*Mewbourne Oil Company***Plug and Abandon**

Wellname: Resler Yates State #380**Location:** 2130' FNL & 990' FEL; Sec 32, T18S, R28E; Eddy Co., NM**Date:** August 8, 2025**API #:** 30-015-20215**Surf Csg:** 8 5/8" 28# H-40**Prod Csg:** 5 1/2" 14# J-55**Surf Set :** 532'**Prod Set:** 2080'**Perfs:** 2036'-2046' (20 shots)**Tbg:** 2 3/8# 4.7# N-80**Tbg Set:** 1957'

Operator: MEWBOURNE OIL CO P.O. Box 5270 Hobbs, NM 88241	OGRID: 14744
	Action Number: 517868
	Action Type: [C-103] NOI Plug & Abandon (C-103F)

Vertical schematic (actual)

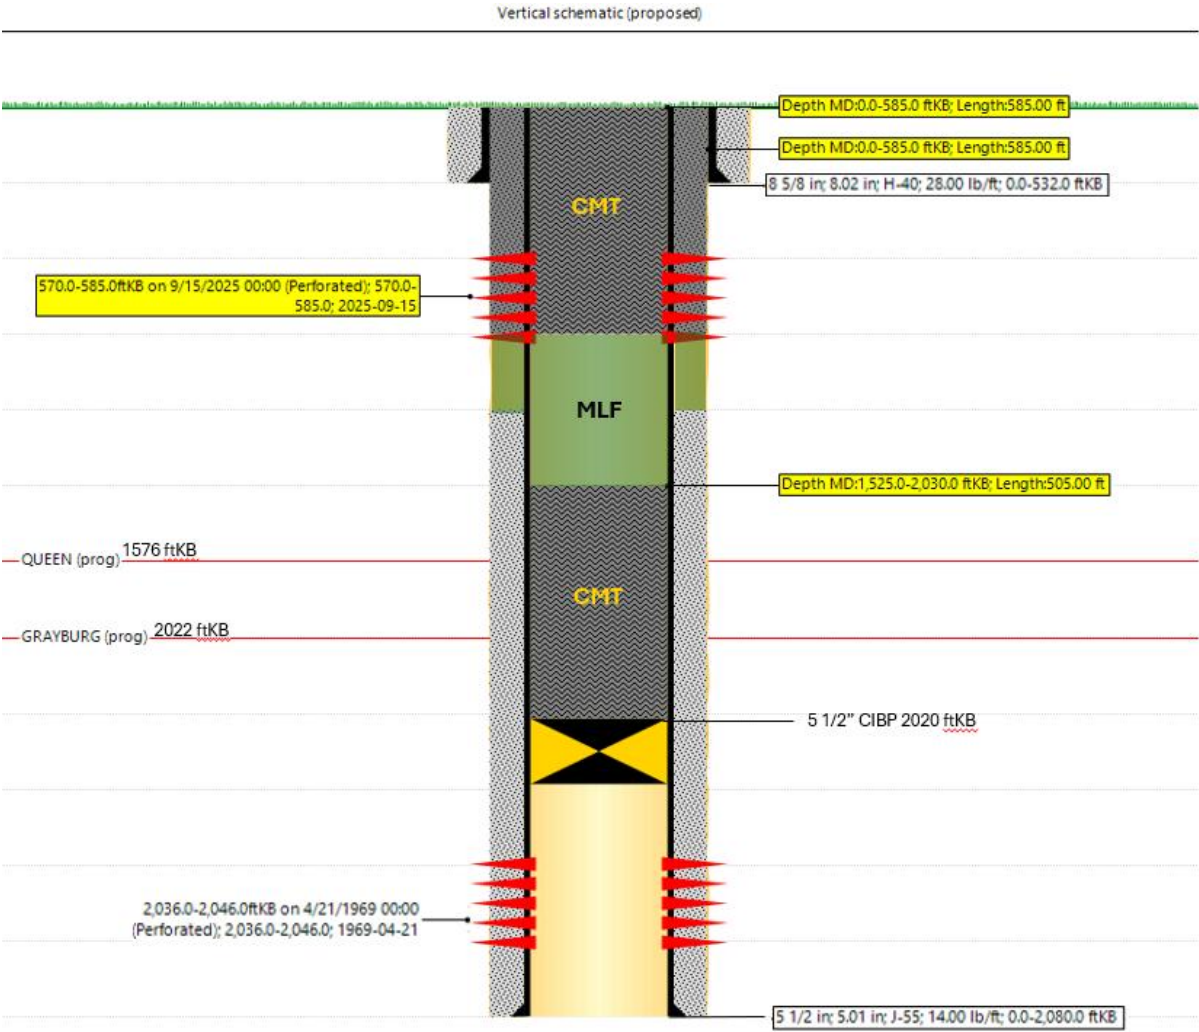
Created By	Condition	Condition Date
loren.diede	Notify the OCD inspection supervisor via email 24 hours prior to beginning Plug & Abandon (P&A) operations.	10/23/2025
loren.diede	Submit the CBL tif file for the NMOCD to upload into the Well Log File.	10/23/2025
loren.diede	NMOCD has determined that this well is not within the LPCH restricted area and an above ground P&A marker is required.	10/23/2025
loren.diede	Submit a photo and GPS coordinates of the P&A marker with the final P&A reports. The API # on the marker is to clearly legible.	10/23/2025
loren.diede	NMOCD requires that a plug(s) is to be added to cover the 7 Rivers = (960') and Yates = (760') formation tops	10/23/2025
